Access Compliance Report

Public Rights-of-Way

Intersection ID: 45563	Main Street: MT_HOLLY-HUNTERSVILLE_RD	Cross Street: MOUNT_HOLLY_RD	Location:	N
ADA ID: F3CFC238F9DD	Ramp Type: PerpDiag	Initial Pass/Fail: Pass	Overall Compliance: No	Severity Score: 2.5

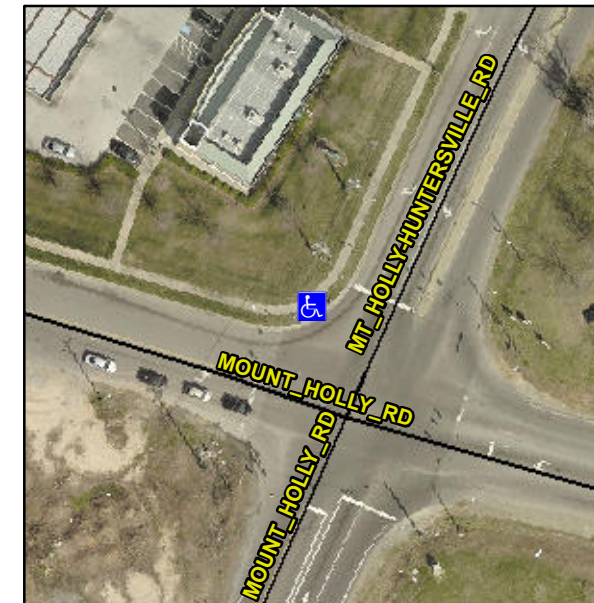
R304.2.1, R304.2.2-Perp, R304.3.2-Para, R305.1.4, R305.2

Remove & Replace Curb Ramp With Two New Directional Ramps or Equivalent.
